Model: PB3030 (PR-C1 2-paper tray unit)		Date: 20-Sep-07	No.: RD331001
Subject: Friction pad		Prepared by: M. Ishihara	
From: 1st Tech. Support Sec. Service Support Dept.			
Classification:	<input type="checkbox"/> Troubleshooting <input type="checkbox"/> Mechanical <input type="checkbox"/> Paper path <input type="checkbox"/> Product Safety	<input type="checkbox"/> Part information <input type="checkbox"/> Electrical <input type="checkbox"/> Transmit/receive <input type="checkbox"/> Other ()	<input checked="" type="checkbox"/> Action required <input type="checkbox"/> Service manual revision <input type="checkbox"/> Retrofit information

Model: PB3030 (PR-C1 2-paper tray unit)		Date: 26-Jun-09	No.: RD331002
Subject: Spacer: Supporter: Right		Prepared by: M. Ishihara	
From: 1st Tech. Support Sec. Service Support Dept.			
Classification:	<input type="checkbox"/> Troubleshooting <input checked="" type="checkbox"/> Part information <input type="checkbox"/> Action required <input type="checkbox"/> Mechanical <input type="checkbox"/> Electrical <input type="checkbox"/> Service manual revision <input type="checkbox"/> Paper path <input type="checkbox"/> Transmit/receive <input type="checkb

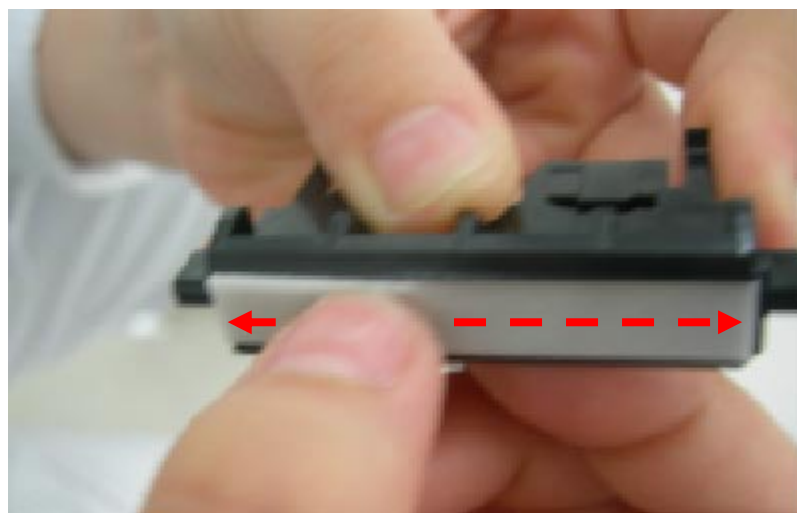
Symptom

Dog ears may occur when the paper is fed from the optional 2-tray paper unit.

Cause

Part of the friction pad peels off the pad bracket.

Action

Do the following when you install the optional 2-tray paper unit on the Parisian-C1:

Press the friction pad firmly with your thumb, and while doing so, slide your thumb across the length of the pad. Do this three or four times.

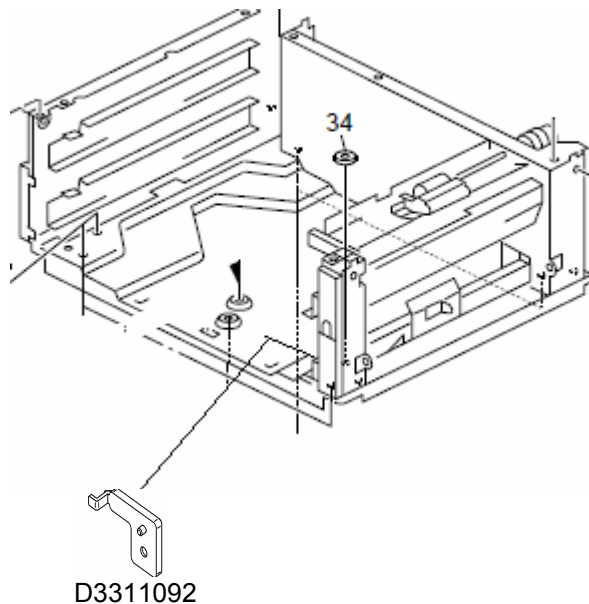
Old P/N	New P/N	Description	Q'ty	Int	Page	Index	Note
-	D3311092	Spacer: Supporter: Right	0-1	-	3	35	New

Change/Reason: This part was missing in the parts catalog of the Paper Feed Unit PB3030 (D331).

4.Electrical Section 1 (D331)

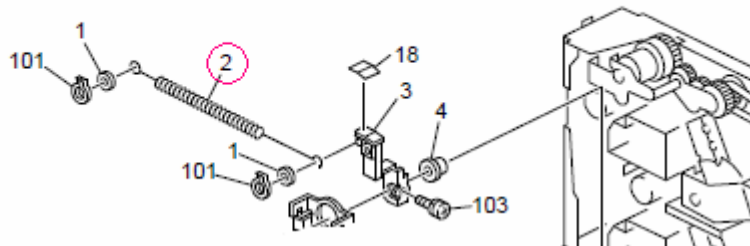
Old P/N	New P/N	Description	Q'ty	Int	Page	Index	Note
-	D3312774	Tension Spring: Paper Feed: 2	1	-	9	2	New

Change: The spring was added as a service part.

Reason: To minimize non-feed paper jams that can occur when feeding "Yes Color 100g" paper.

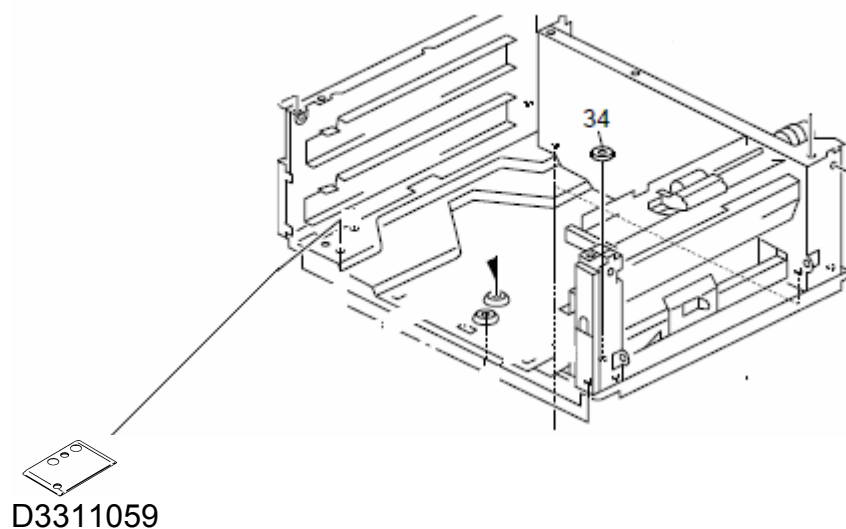
Old P/N	New P/N	Description	Q'ty	Int	Page	Index	Note
-	D3311059	Guide: Paper Tray	0-1	-	3	36	New

Change: A guide was added to the area shown below.

Reason: To minimize the sound that occurs when the paper tray is pulled out or pushed in.

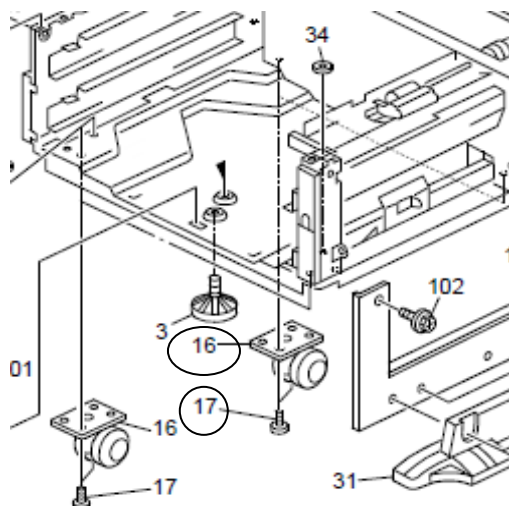
Old P/N	New P/N	Description	Q'ty	Int	Page	Index	Note
AH012037	D3511121	Caster	4-4	X/X	3	16	
B8001103	A5071096	Philips Screw – M5x6	8-8	X/X	3	17

Change: The thickness of the caster holder has been made thicker than the old one.

Reason: Vendor change

Note: Those parts are interchangeable as a set.

2. Paper Tray (D331)

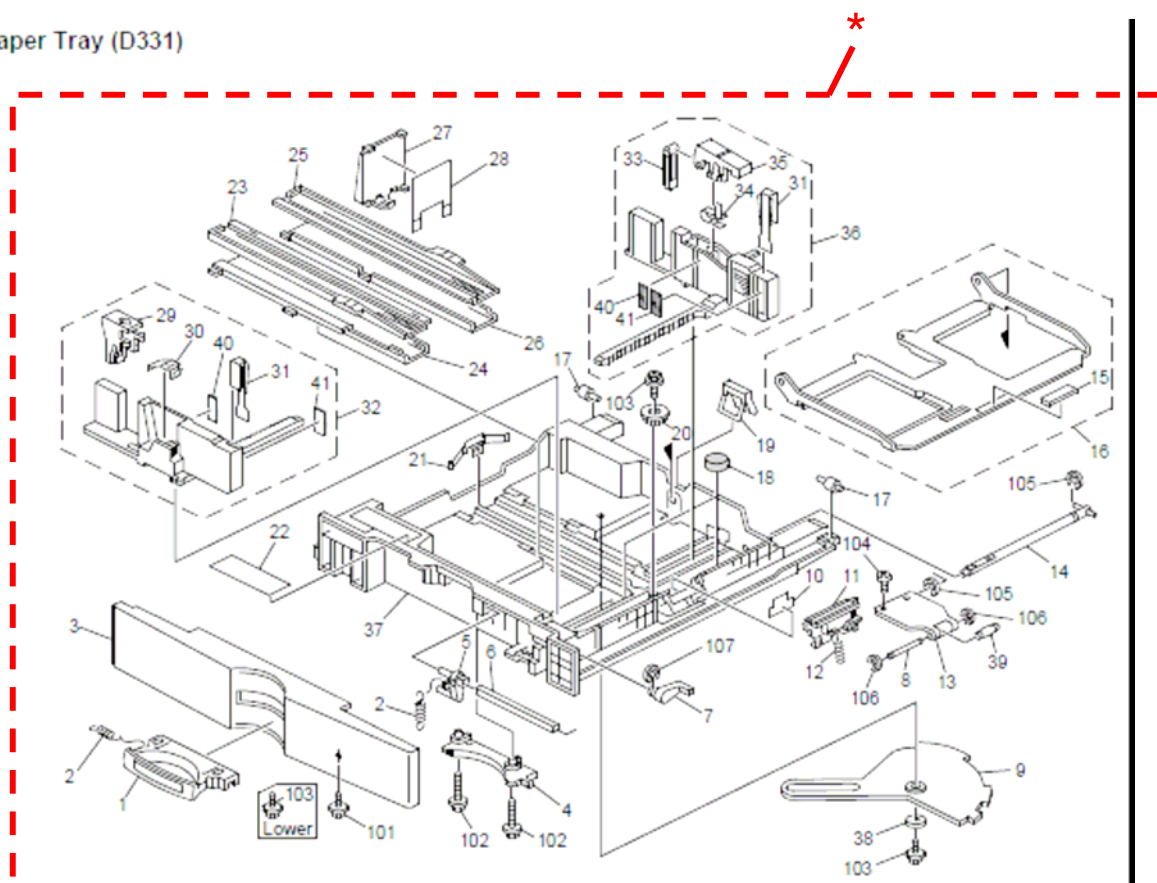
Old P/N	New P/N	Description	Q'ty	Int	Page	Index	Note
-	D3312531	Paper Tray: Lower Position: BALI-D: Ass'y	0-1	-	5	*	
-	D4252532	Paper Tray: GUAM-C: Ass'y	0-1	-	5	*

Change / Reason: These assembly parts are now available as service parts.

Note: D3312531 is for the lower tray and D4252532 is for the upper one.

New Index: 25 #D4252558 (Spacer: Adhesion)

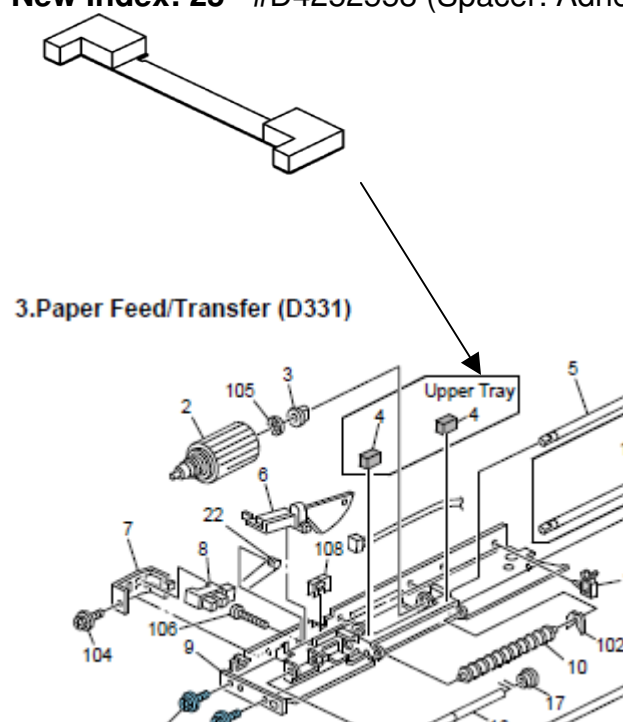
Old P/N	New P/N	Description	Q'ty	Int	Page	Index	Note
A8602559		Cushion Guide Plate	2-0	-	7	4	
-	D4252558	Spacer: Adhesion	0-1	-	7	25	New index

Change: 2 cushions were assembled and became the spacer (D4252558) as shown in the figure below. The spacer is affixed on the upper tray only.

Reason: To unify the part with other models.

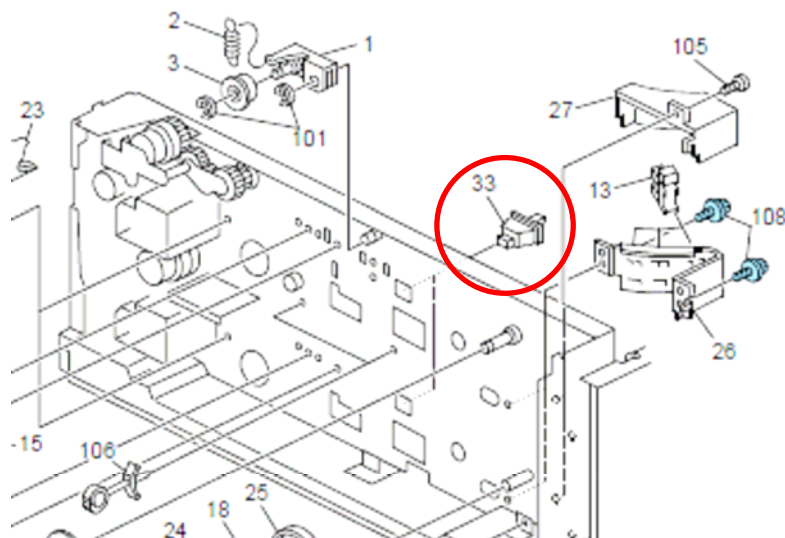
Old part number	New part number	Description	Q'ty	Int	Page	Index	Note
	G0205626	PUSH SWITCH			11	33

Change: An index for the illustration is added.

Reason: The part information was not available.

See the following diagram for the part location.
